APPROVED MINUTES

November 18, 2022 Standards Committee Meeting

RE: Minutes from the November 18, 2022 Standards Committee Meeting

PRE-COMPRESSED FOAM JOINT DETAIL

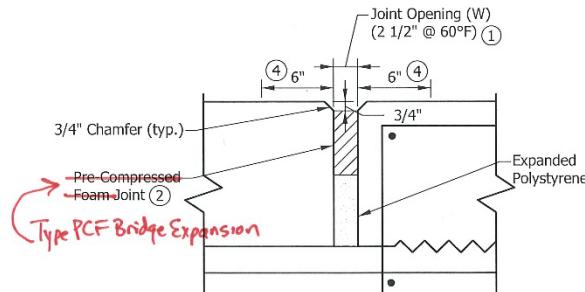
~~Pre-compressed foam joints, PCF~~, *This joint shall be furnished from the Department's list QPL of approved Type PCF Bridge Joints. PCF* Joints may be added to the ~~approved list QPL~~ by completing the requirements of ITM 806, Procedure C.

E 724-BSSJ series EXPANSION JOINTS (WITH MARKUPS)

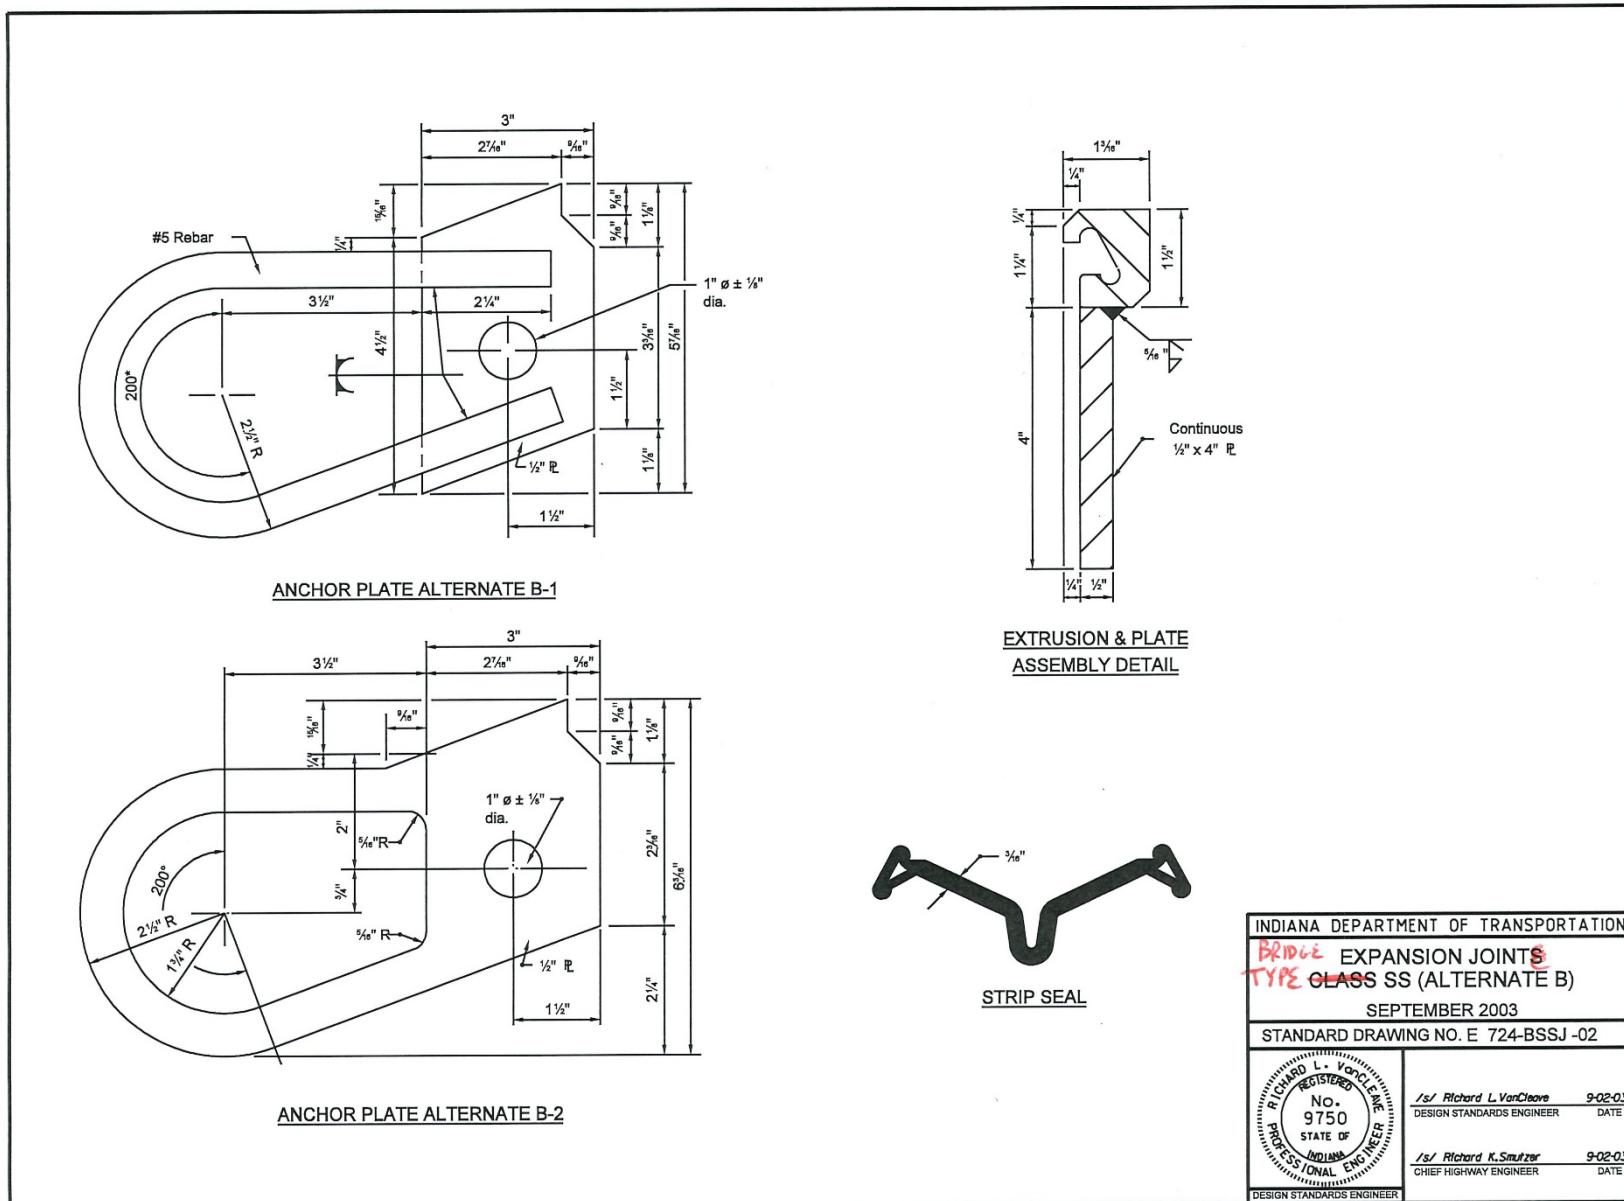
9. have a hollow box shape for joints utilizing urethane *or mechanical* equilibrium control spacers or a strip seal configuration for joints using a mechanical linkage to maintain equidistant separator beam spacing. The joint shall have a maximum opening of 3 in. per seal.
